**VILLAGE OF GERMANTOWN
N112 W17001 MEQUON ROAD
GERMANTOWN, WI 53022**

MEETING:	REGULAR MEETING OF THE PLAN COMMISSION
DATE AND TIME:	Monday, May 8, 2023 6:30 PM
LOCATION:	Germantown Village Hall Board Room N112 W17001 Mequon Road

ITEM TITLE: MSI General Inc., Agent for Moldmakers Investments LLC,
Property Owner of MGS Manufacturing, W188 N11707 Maple
Road. Site Plan Review for a 118,652 sqft Innovation Center
Addition. **(ACTION)**

To : Jeffrey W. Retzlaff, AICP, Planning Director/Zoning Administrator
From : Lawrence Ratayczak, P.E., Director of Public Works
Date : April 6, 2023
Re : MGS Expansion

Sheet Title:
EXTERIOR ELEVATIONS

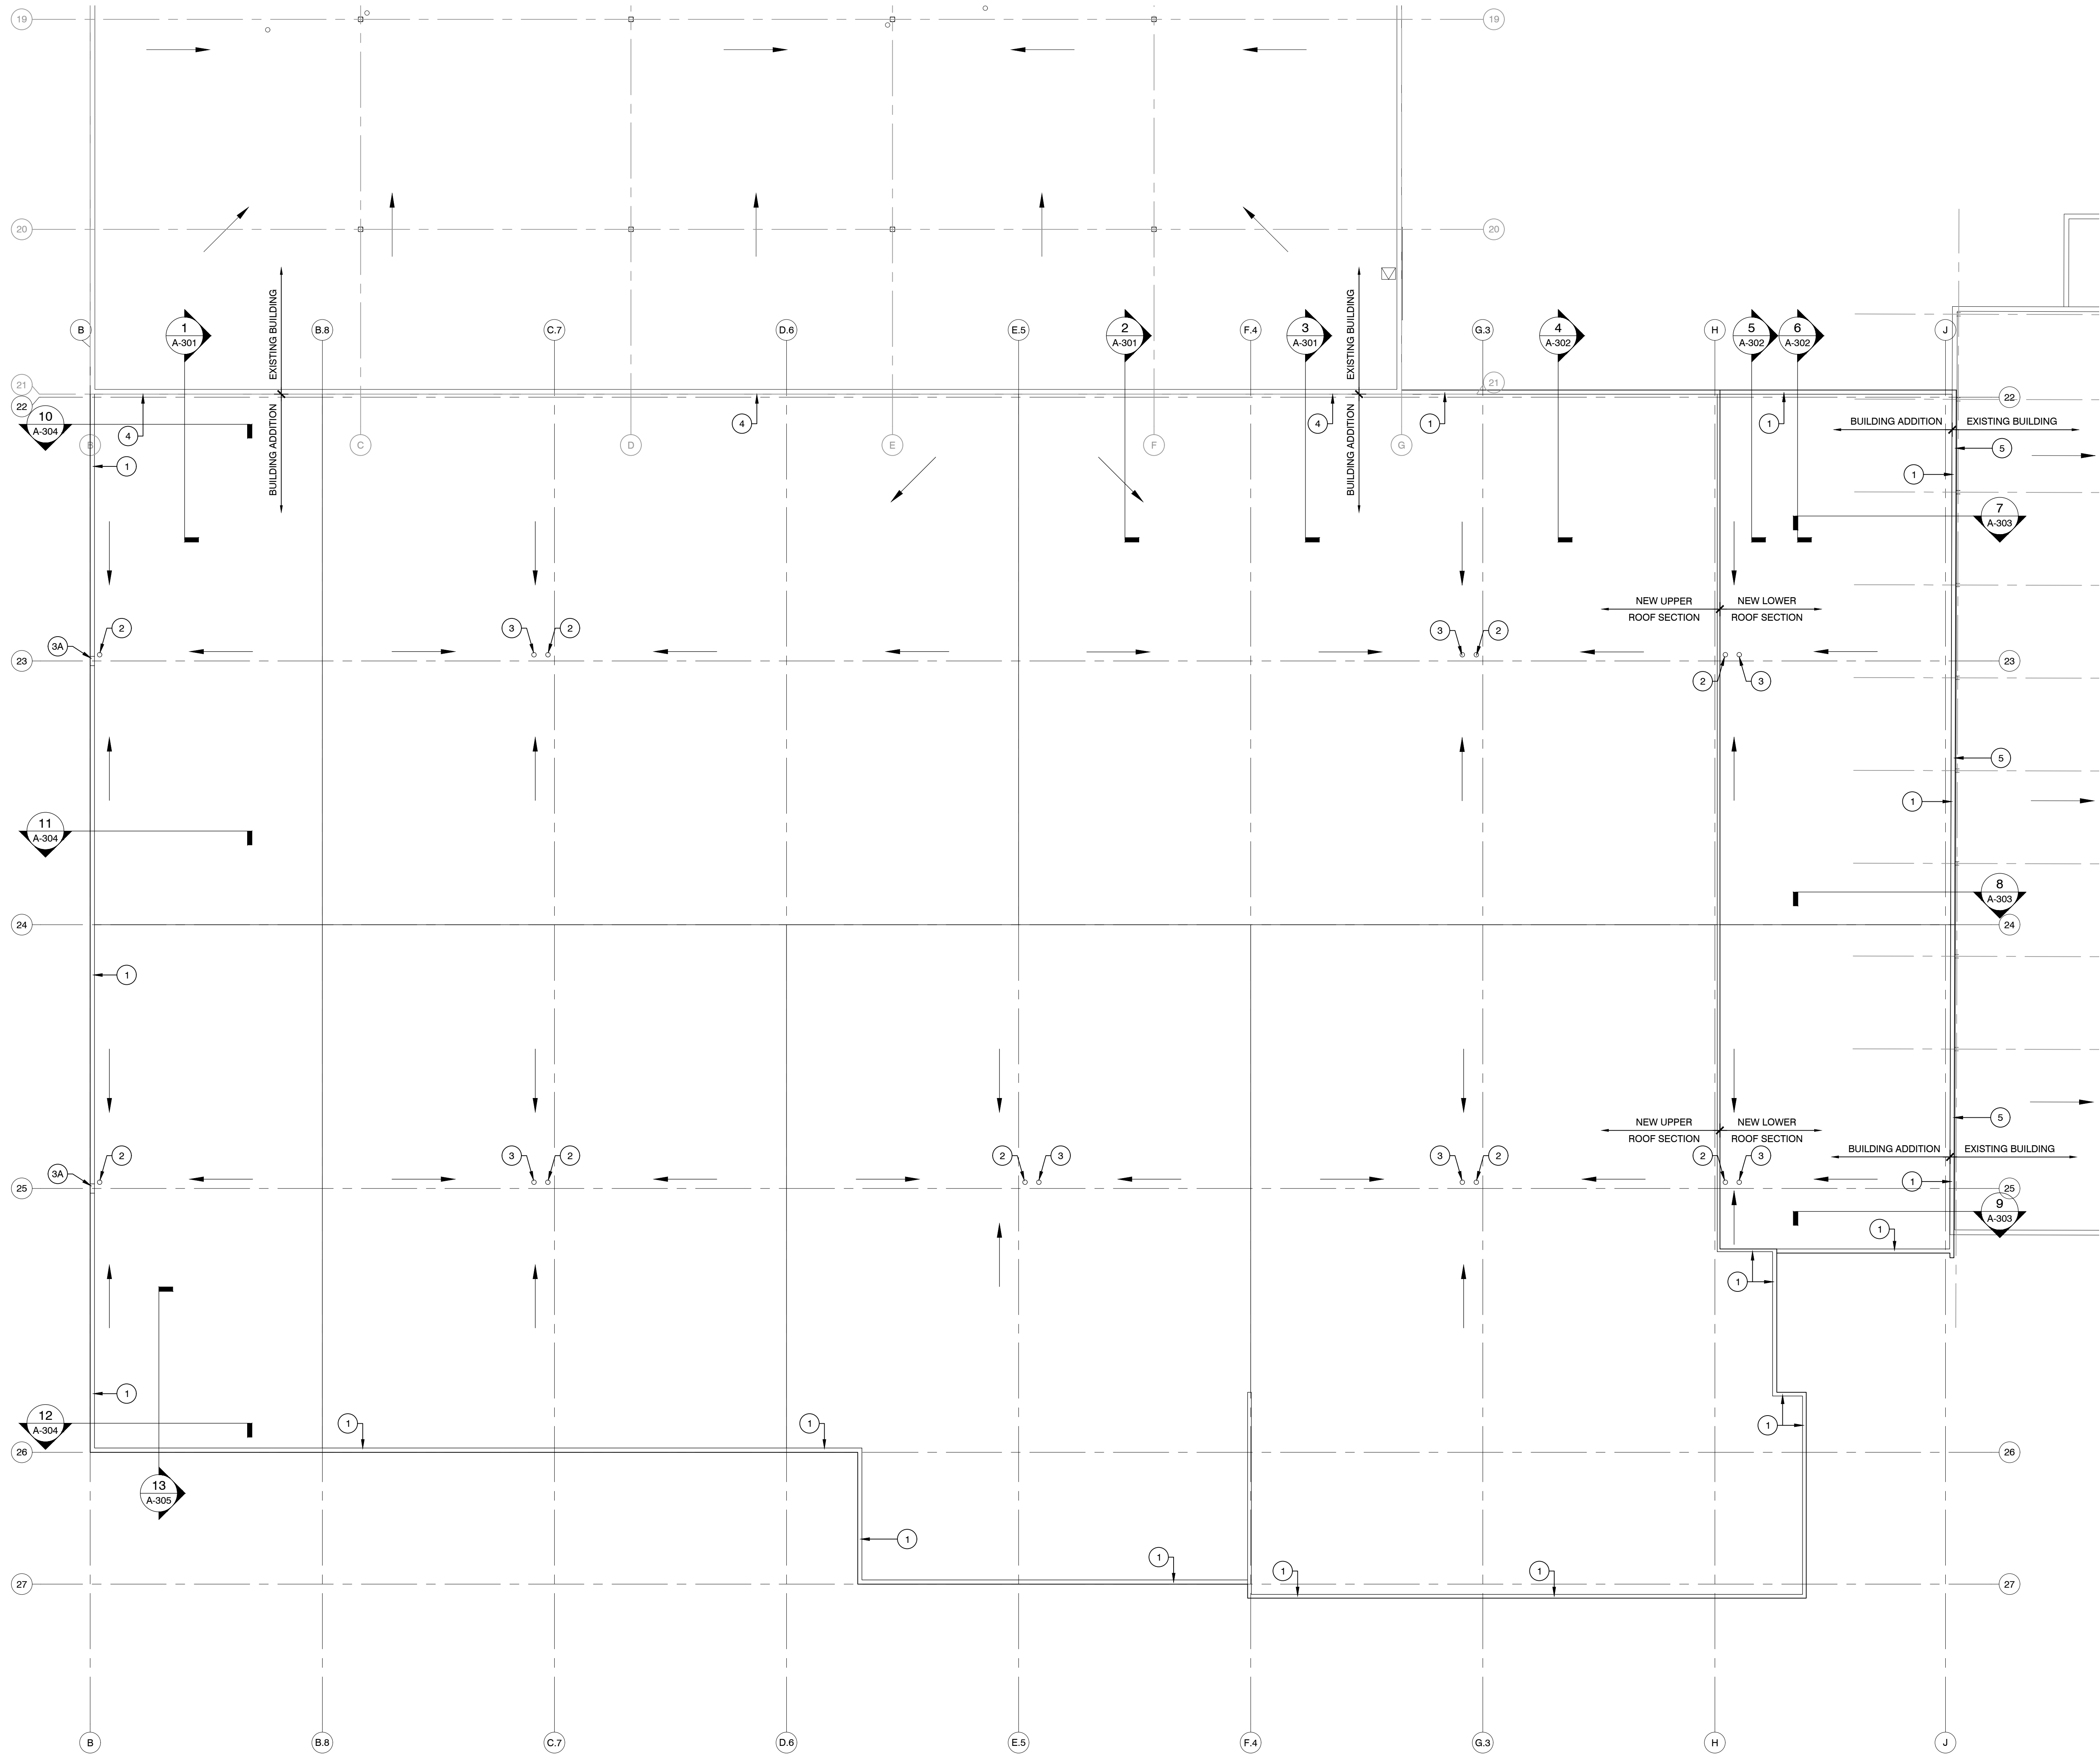
Trustee Baum asked why the building elevations have so many knockout panels. Mr. Navis explained the building was designed for future flexibility. Discussion followed on when Plan Commission would review a

change to the knockout panels. Trustee Baum was concerned the lower knockout panels could be changed to overhead doors.

MOTION to Amend Baum second Tarantino that if the knockout panels on the north or east side of the building are used for overhead doors, Plan Commission approval is required.

Sheet Number: C-101

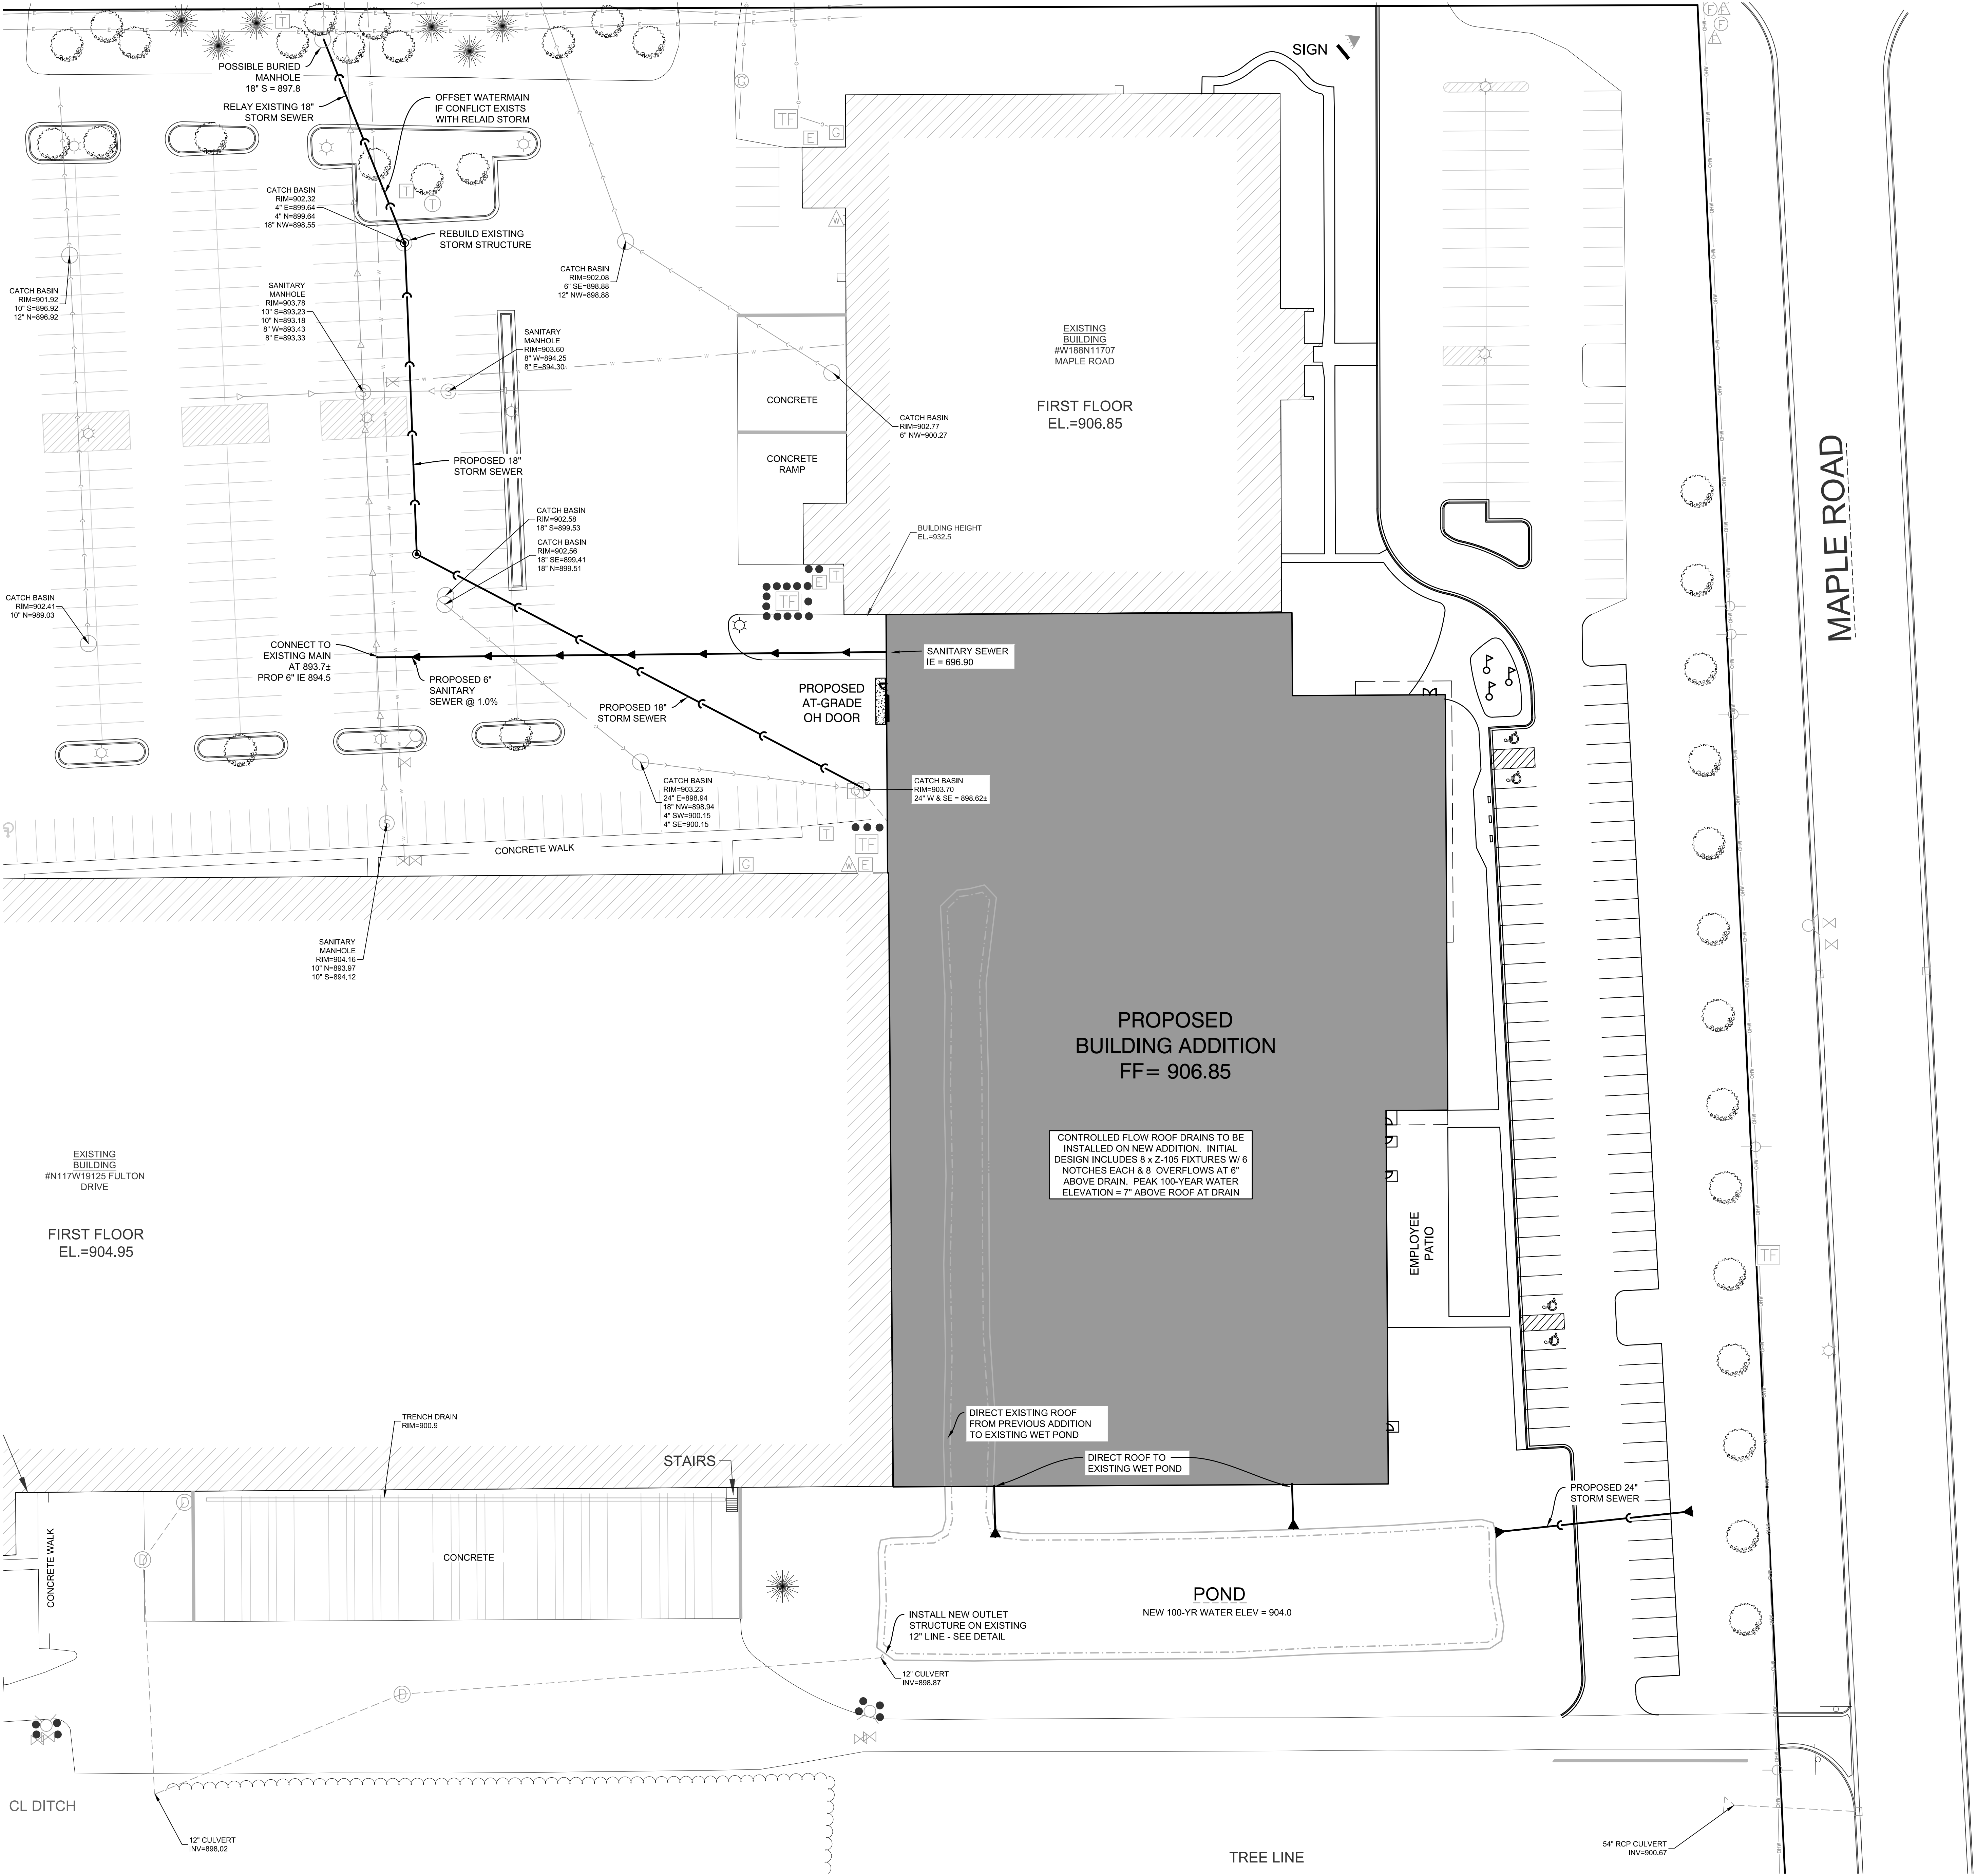
1. Clarify extents of proposed verse existing sidewalk to the north of the proposed addition.
2. Show and callout ADA ramps, truncated domes, and ADA signage.
